Development Services Department  
Staff Recommendations Concerning Required Findings

Project: 4213 Waters Edge Cove Bulkhead

Variance Request: Approval for their newly construction bulkhead which is wider than allowed by code.

## ENVIRONMENTAL COMMISSION VARIANCE APPLICATION FORM

# CONCRETE HEADWALL SECTION DETAIL 01

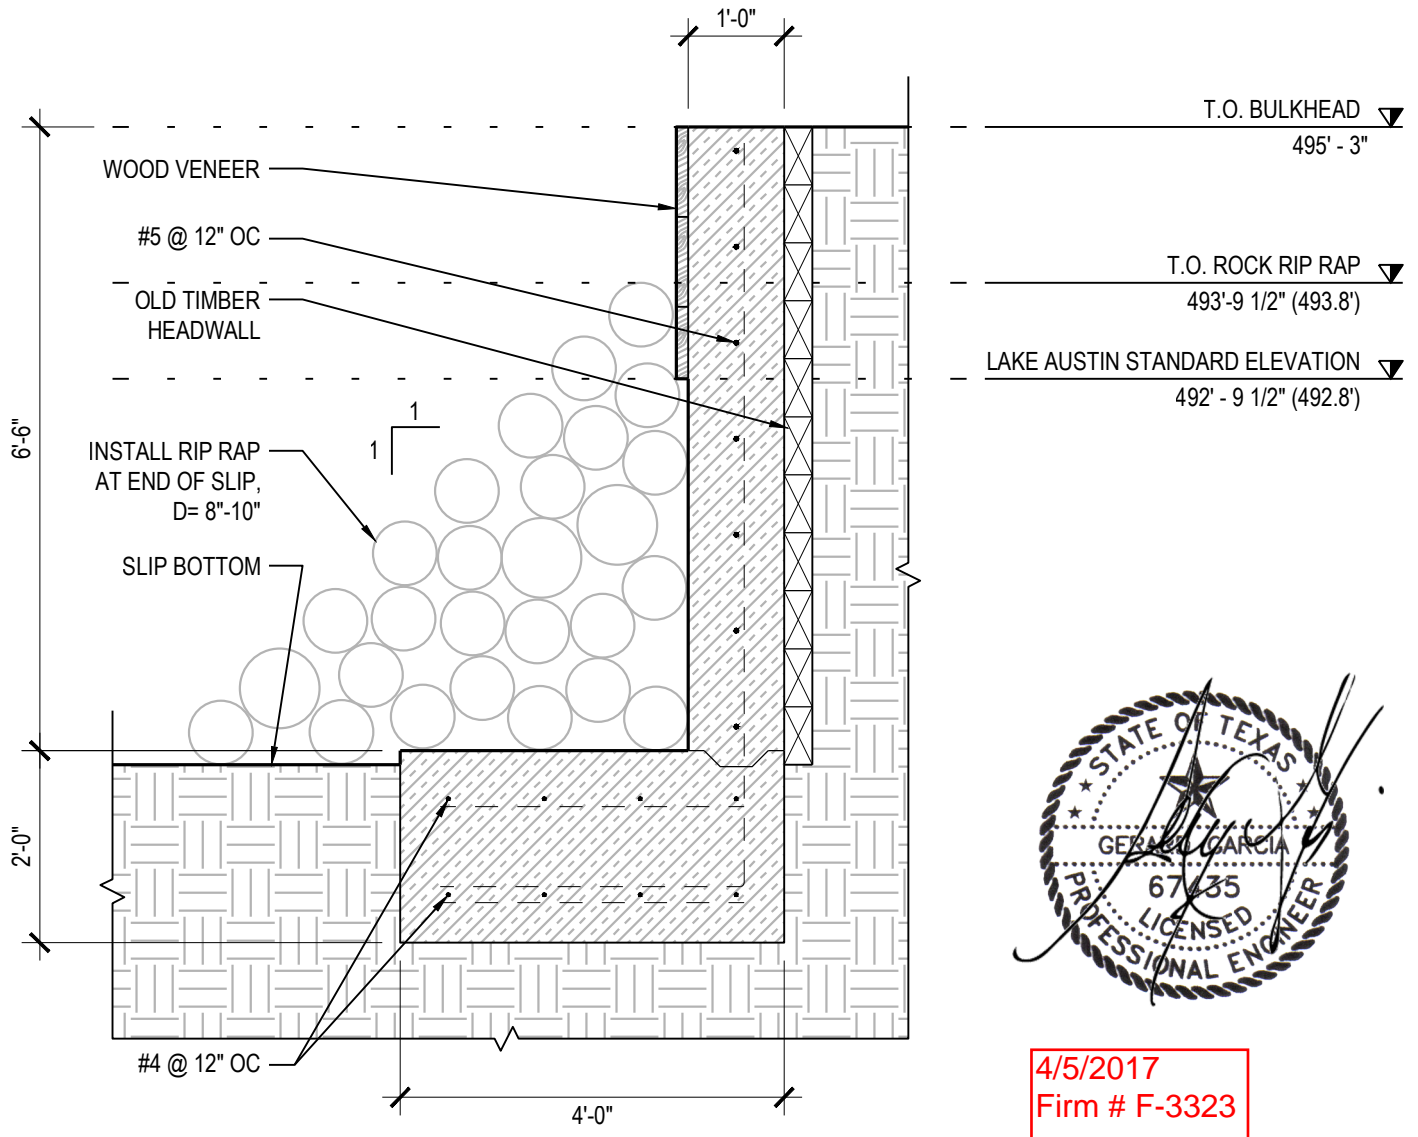
Yes / No Yes. Because of the existing boat dock impeding full site access and a structural requirement for the concrete bulkhead to be 12" instead of the code-required 6", the now as-built condition was the only option available to achieve protection of the boat slip, yard, and potentially part of a home upon finding their existing bulkhead was failing.

Yes / No Yes. The existing boat dock impeded access to the site for installation of sheet piling, so the next option was pouring concrete. To ensure structural integrity, the concrete wall needed to be wider than a sheet pile wall.

Based on the required height of the bulkhead (approximately 6.5 feet) and the lateral loads induced, structural requirements dictated a 12" thick wall. A 6" concrete wall was found not to be structurally sufficient.

The option of a sheet pile installation was not considered as the existing overhang of the boat dock roof did not allow for proper access for pile driving equipment.

Staff Recommendation: Approve with conditions.
